**SERVICE LETTER NUMBER 167**  
**10000 PROBE JACK END PLUG LOOSENING**

<b>By:</b> BGLASS	<b>Aircraft Makes/Model(s):</b> AT802A AT802 (2-Place)	<b>Float Model(s):</b> 10000A	<b>Note(s):</b> Mandatory Compliance Service Letter P/N 1008745
<b>Approved:</b> JRS			
<b>Date:</b> 5/5/2016			
<b>Rev:</b> A

This service letter applies to: AT802/AT802A with Wipline 10000 Amphibious Floats installed per STC SA01795CH

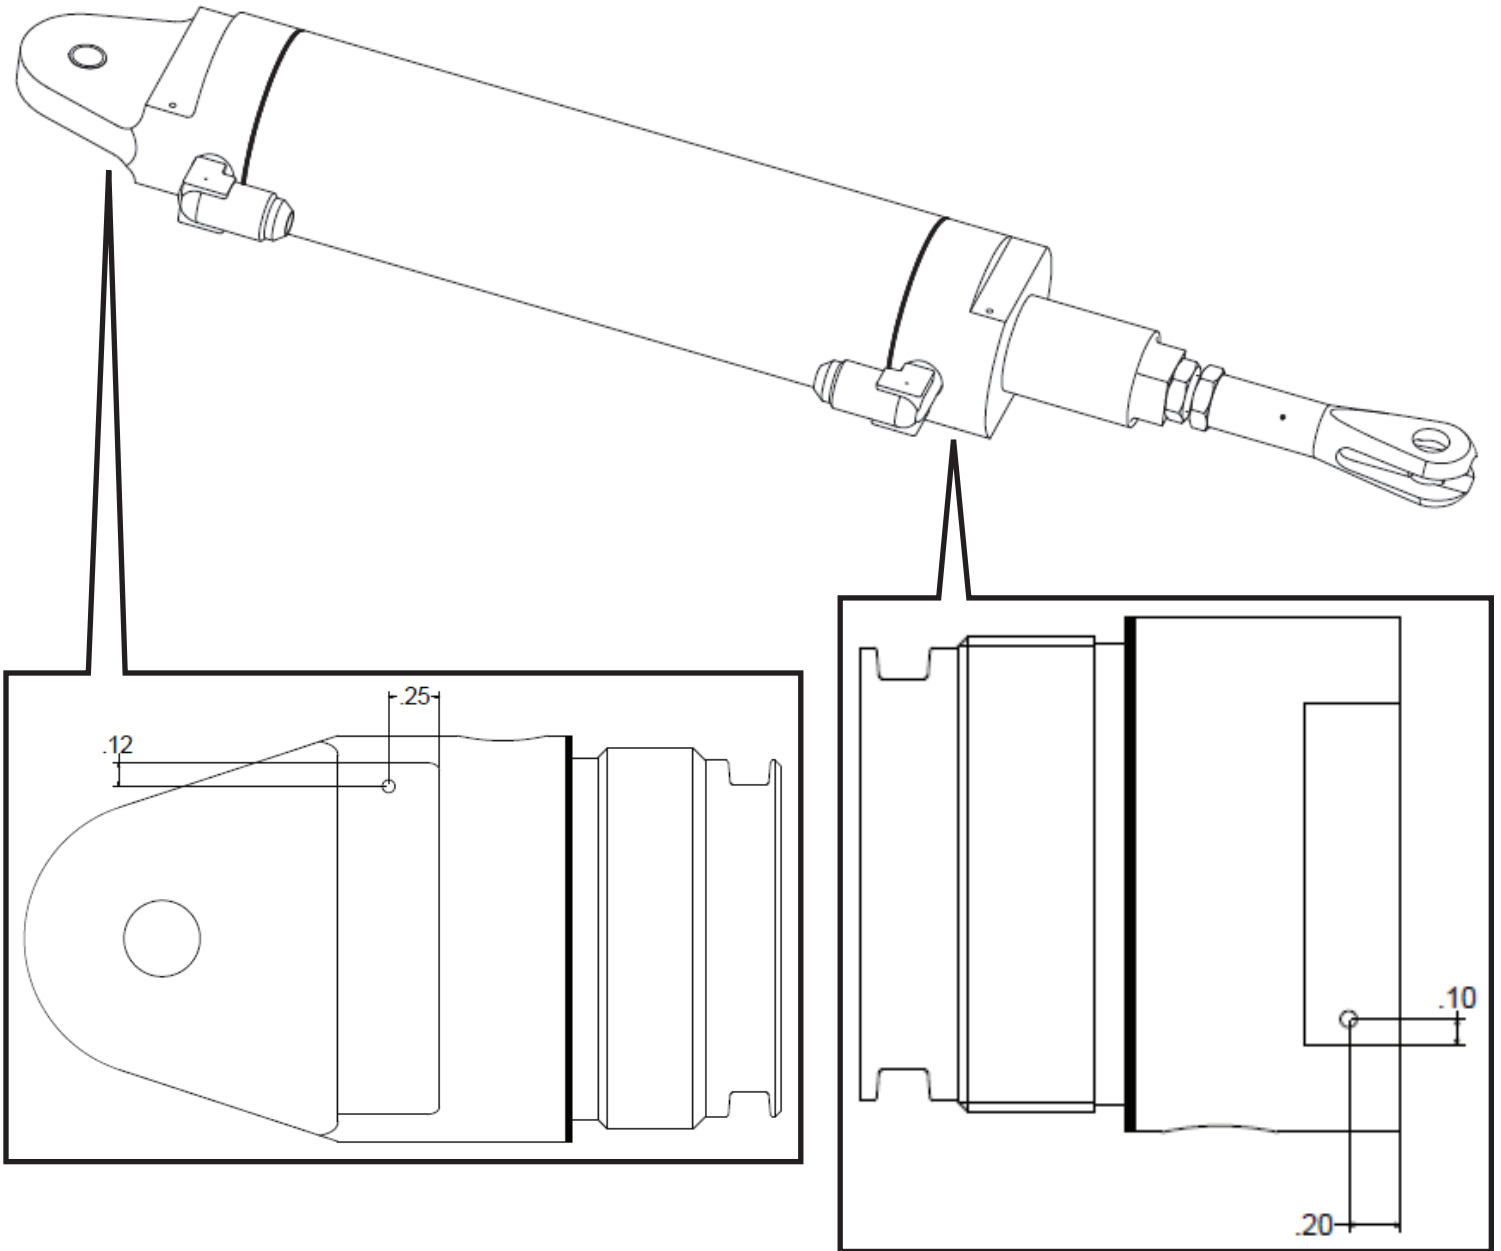
Hydraulic leak near the probe jack cylinder in the float have been reported. Upon further investigation, Wipaire have found that the end plug on the probe jack is coming loose

If signs of loosening are found on the end plug, safety wire probe jack cylinder front and end plugs as instructed in the work instructions of this service letter

1. Remove (2) AN6-41A bolts and set aside for reinstallation of the probe jack cylinder

7. Drill (2) 0.063" holes through probe jack end plug and probe jack front plug where shown

8. Attach 0.032" safety wiring through holes in a tightening direction
9. Reinstall probe jack cylinder assembly
10. Cycle scooping system checking for interference and make any adjustment as required per applicable service manual
11. Reassemble float as to return to service
